RIDGWAY PLANNING COMMISSION

STAFF REPORT

Request: Variance for Rear Building Setback, Building Height, and Parking
Legal: Block 33, South 15 feet of the West 50' of Lot 18, West 50' of Lots 19 and 20
Addresses: 521, 523, 525 Clinton Street
Parcel #: 430516208006
Zone: Historic Business (HB)
Applicant: Sundra Hines for Greg Young
Owner: Banco Building LLC
Initiated By: Shay Coburn, Town Planner
Date: December 22, 2020

521-525 Clinton Street – Bank Narrative
Planning Commission Hearing Request
Narrative

Site plan showing proposed 3-story addition.

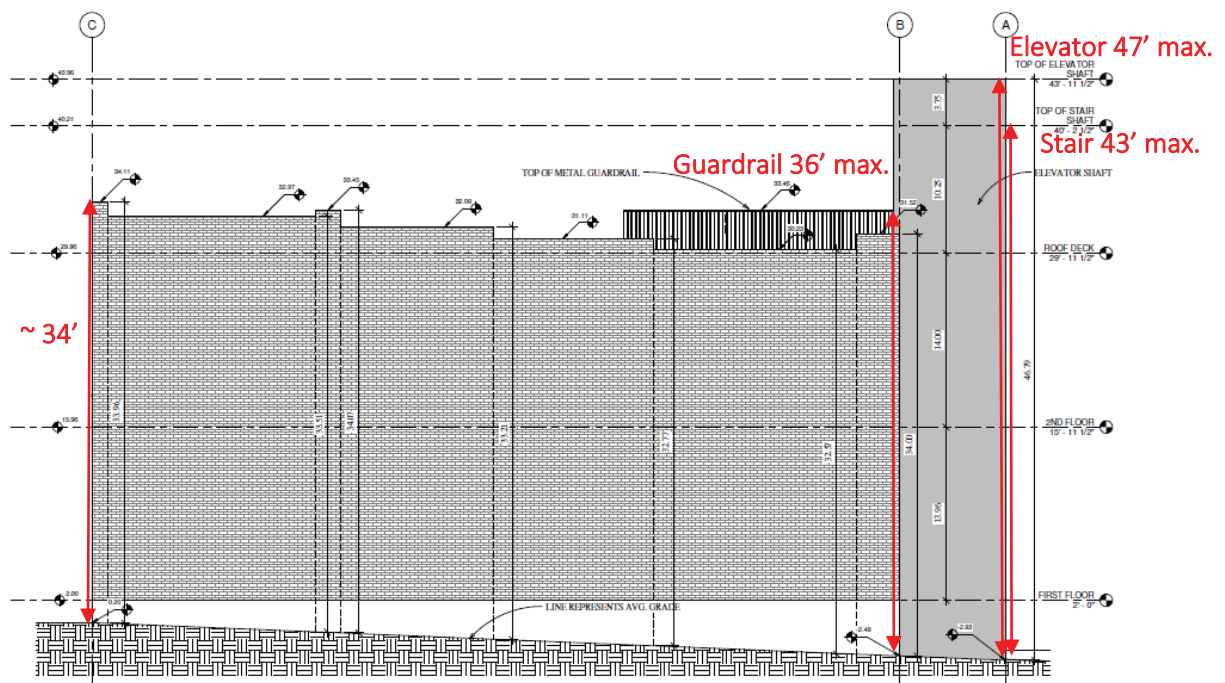
As a historic building, the bank building is built right up to three out of the four lot lines with just 8.5' from the rear of the building to the property line. While the applicant may not need to build right at the rear property line, there are a few unknowns about the requirements for the elevator and stair that may require a 0' setback. It should be noted that the building plans do not propose to use all of the vacant area for the three-story stair and elevator, but rather about 29' of the 50', see diagram below that shows the addition in darker gray with the white areas remaining vacant.

Per criteria 1, there are practical difficulties in trying to maintain an 8' rear setback on this lot while trying to preserve the building and bring in to compliance with current building regulations. The stair and elevator are necessary to meet current ADA and egress building code requirements. To assist in preserving the historic qualities of the building, it is best to add this kind of addition on to the building where possible rather than gutting the inside to accommodate it. In addition, rear setbacks in this district are allowed to be as small as 2' when abutting an alley and the way this building was built across multiple lots is a bit unique. Staff does wonder what will happen with the small undeveloped area to the east of the elevator if the neighboring lot is built to the lot line. Did the Applicant consider moving the addition to adjoin the east property line?

Per criteria 2, the spirit of the ordinance will be observed. Staff feels that the major concern for zero lot line development in this district is drainage and potential impacts to neighboring properties. The applicant has noted that they feel they can accommodate this appropriately. Storm drainage will be complicated on this lot and will need to be carefully thought through to meet the regulations. The public health, safety and welfare will be secured and substantial justice will be done in that this valuable historic building will be given new life and the care that it needs to last for generations to come. This addition will also improve the safety and accessibility of the building as well as other likely modifications to the building will improve the overall safety.

East building elevation showing height measurements.

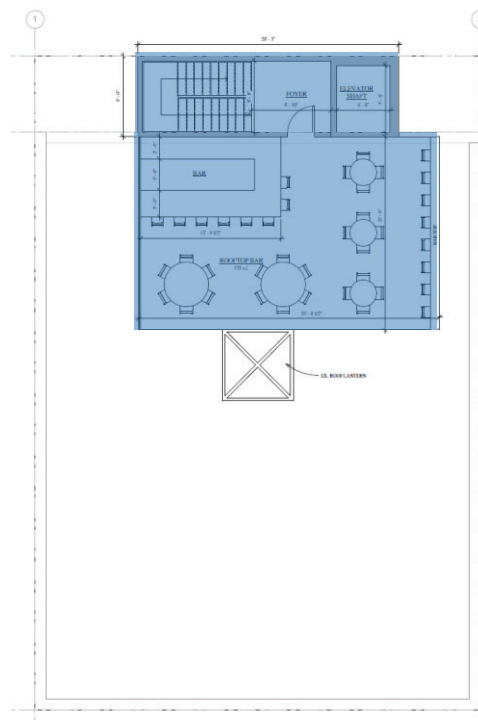
The front of the building, along Clinton Street is just under 34' and considering the terraced parapets that step down in accordance with the natural grade, the rear of the building (the north east corner) appears to be exactly 34' tall. After discussion with the Applicant about the height request detailed in the narrative, the request for a height variance is actually for the top of elevator to be up to 47', the stair to be just over 43', and the guardrail on the roof deck to be up to 36'. It is important to note that the code allows for terraced structures to be measured independently and that by measuring exactly where the addition will meet natural grade, the heights requested herein will likely be a bit less. See the diagram below for measurements.

To address criterion 1, there may be practical difficulty due to working with an established historic building and that the topography of the site appears to drop about 2.5' from the front of the building to the rear. It is understood that a stair and elevator need to be added to meet building code but it is not clear why a roof bar has to be added resulting in a stair and elevator much taller than the code allows. Perhaps the full project cannot pencil out financially without the addition of the roof top bar. It will be helpful for the Applicant to better explain how this variance request meets the practical difficulty or unnecessary hardship criteria.

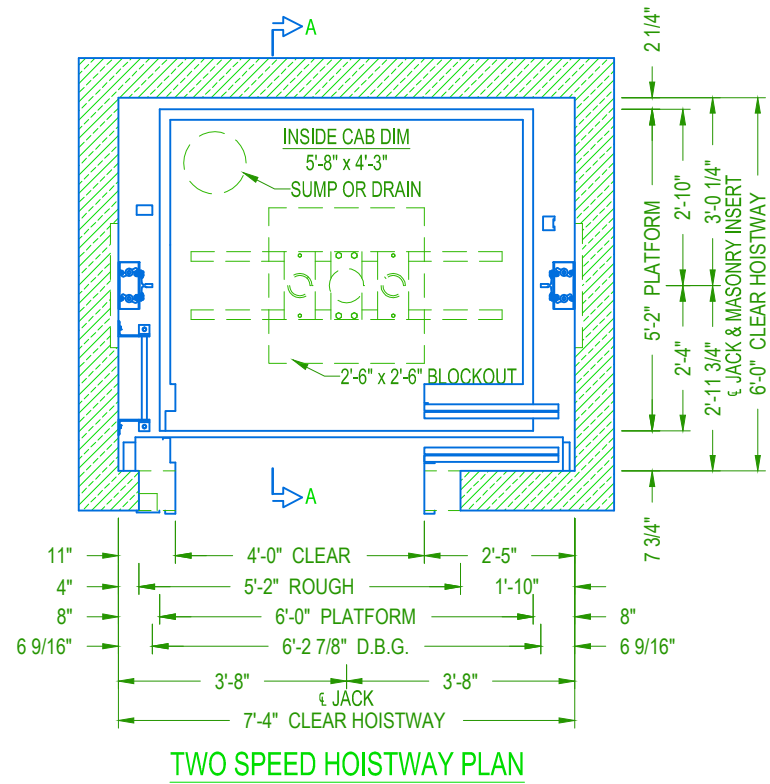
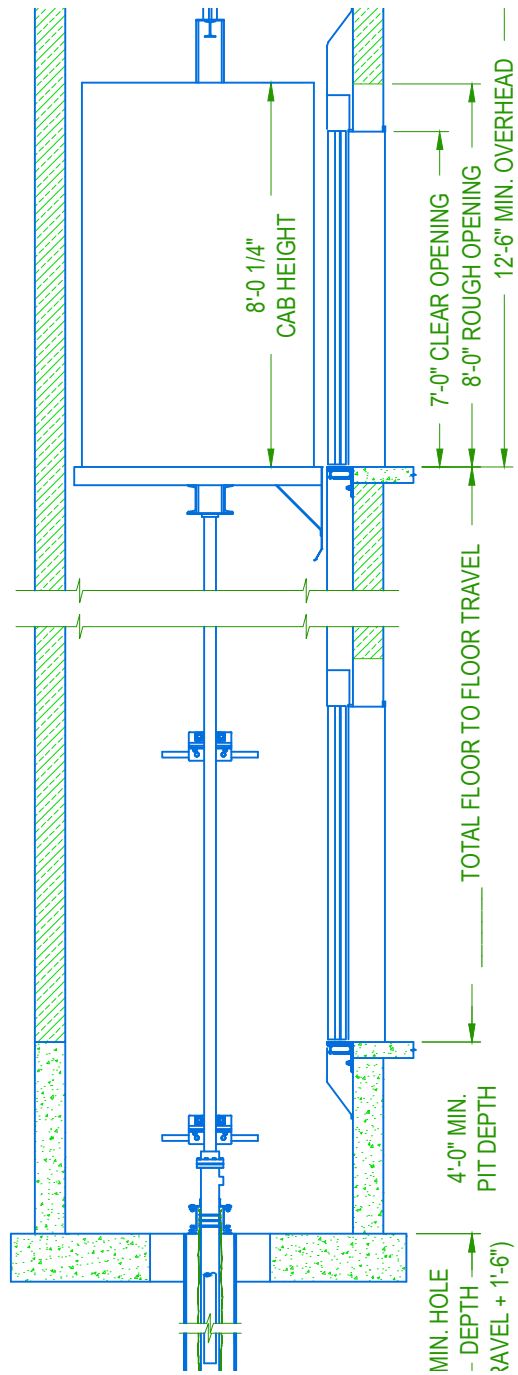
I'd like to explain a little more about the needs of the height variance at the Bank Building. The surveyor has provided us heights of the stepped parapets and the natural grade, which helps to determine the heights at the edge of the existing building, these are shown on the elevations provided. We have laid out the general shape and size of the floor plan of the rooftop bar and therefore can make assumptions about the overall height needed. That said, there are three factors in determining how much height will be needed at the final design stage : 1) construction of the new roof system, 2) layout of the new support beams and posts needed for the rooftop deck and 2) the height needed for the ADA elevator itself. 1) We will be reconstructing the existing roof to include updated insulation, shoring up the roof structure, adding sprinkling systems within the roof plenum and applying a new membrane. With new construction methods, we may be able to minimize the overall depth of roof construction. For now, we are just using the existing heights. We really won't know until we start doing some investigative "demo" work. 2) We would really like to keep and restore the existing roof lantern. Our investigation will include looking at it's support beams to determine how close we can get or if more support is needed for it. This may have an impact on the roof structure itself. 3) The first two items will help to determine the height of the deck surface, which will help us determine the height of the elevator shaft. I've attached a diagram of the elevator we are looking to use. This unit requires 12'-6" above the deck surface.
